## PLAT COMMITTEE

March 13, 2024

<b>Case Number:</b>	2024-PLT-009
<b>Property Address:</b>	5101 E Thompson Road ( <i>Approximate Address</i> )
<b>Location:</b>	Franklin Township, Council District #24
<b>Petitioner:</b>	BT Indianapolis, by Matthew Maple
<b>Zoning:</b>	C-4
<b>Request:</b>	Approval of a Subdivision plat to be known as BT Indianapolis, dividing 7.527 acres into four lots, with a waiver of the sidewalk requirement.
<b>Waiver Requested:</b>	Waiver of sidewalks
<b>Current Land Use:</b>	Commercial
<b>Staff Reviewer:</b>	Michael Weigel, Senior Planner

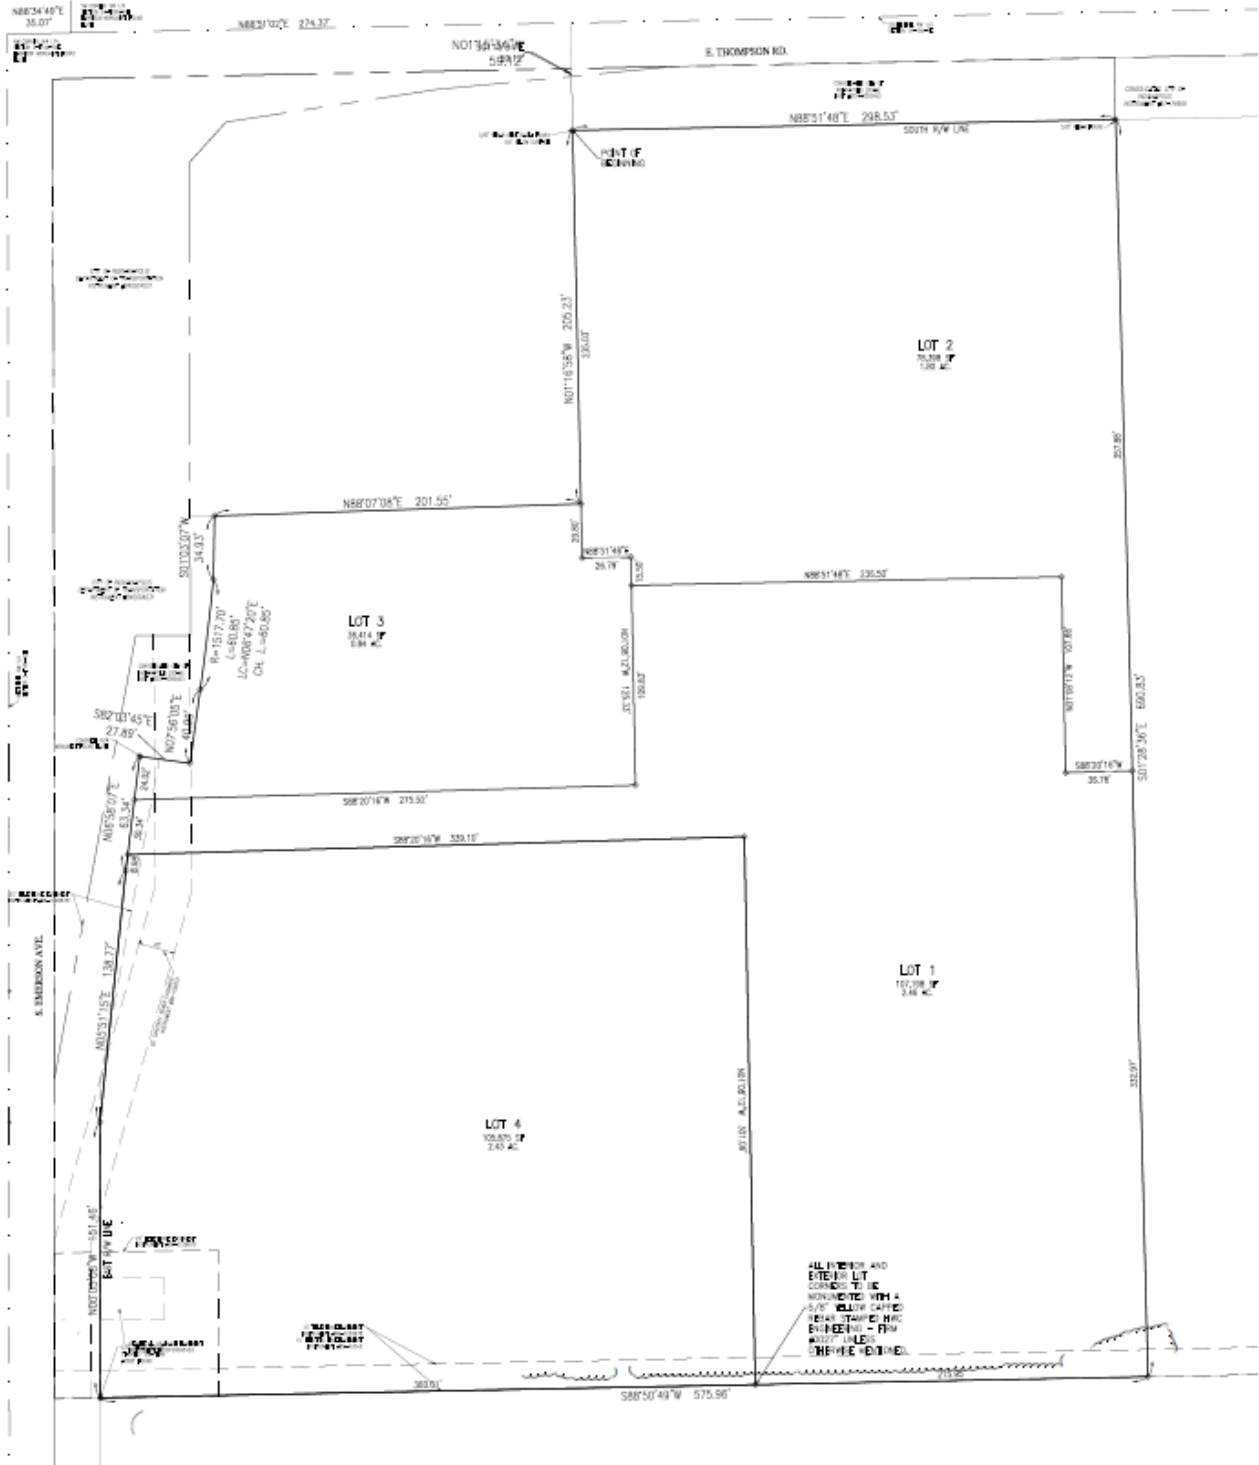
There is currently existing sidewalk along both sides of Emerson Avenue. Sidewalks would be required along Thompson Road (approximately 300' in total length). There is not currently existing pedestrian connectivity servicing the existing multitenant commercial center on either side of Thompson Road, and the applicant claims that the existing drainage ditch and utility site along Thompson would not make installation of sidewalks feasible. Provided findings of fact also indicate that a pathway would be installed through the center of the property to provide internal connectivity (see layout in Exhibits).

Evidence has not been provided to substantiate the claim that any added costs of sidewalk installation near a drainage ditch would outweigh the positive benefits of pedestrian connectivity recommended by comprehensive plans and required by ordinance. Staff would recommend denial of the waiver request. If the plat committee approves the waiver against staff's recommendation, a contribution in lieu of sidewalk installation should be required as a condition of approval subject to Section 744-301.G.

10. That the plat restrictions and covenants, done in accordance with the rezoning commitments, be submitted prior to recording the final plat.
11. That all the standards related to secondary plat approval listed in Sections 741-207 and 741-208 of the Consolidated Zoning and Subdivision Ordinance be met prior to recording the final plat.
12. That the sidewalk waiver request be denied.

**2024PLT009 ; Proposed Internal Pathway**

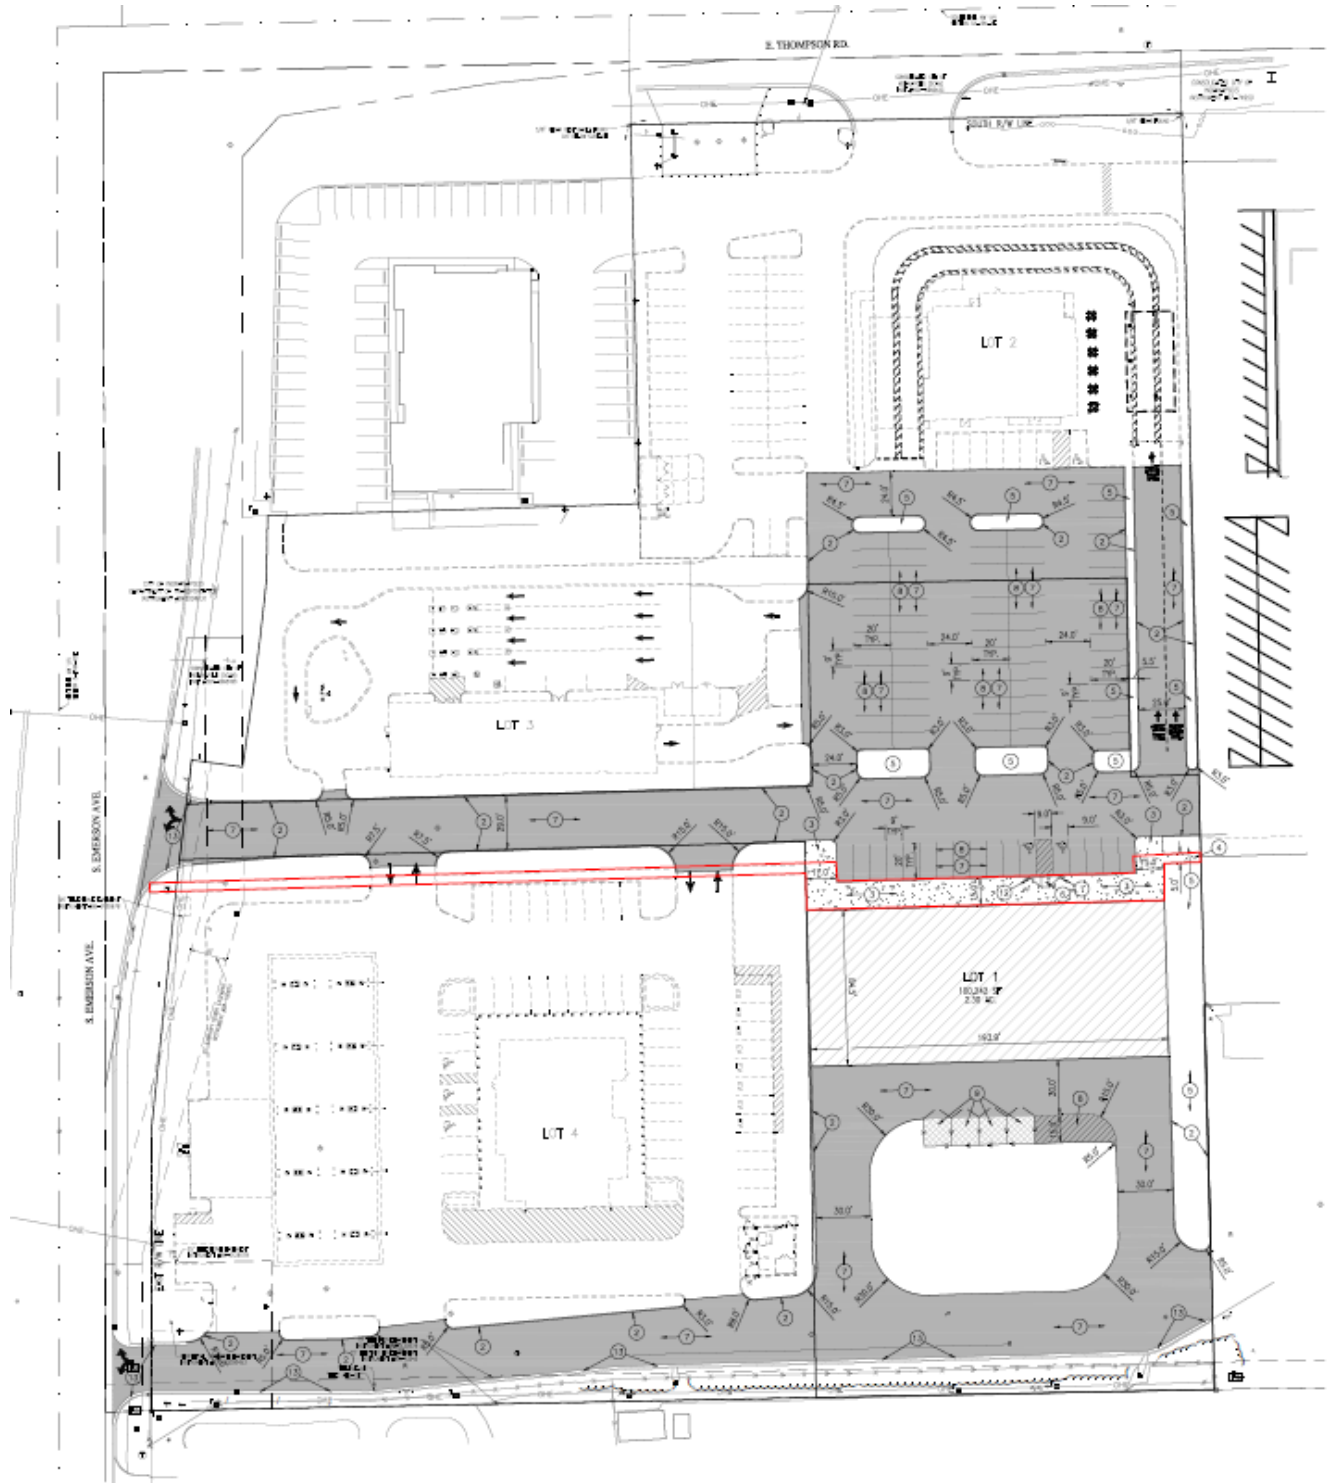
An internal pathway is planned for the BT Indianapolis development that would connect the sidewalk from Emerson all the way to the east side of the BT Indianapolis development to connect to the Emersonn Plaza 2 infrastructure.
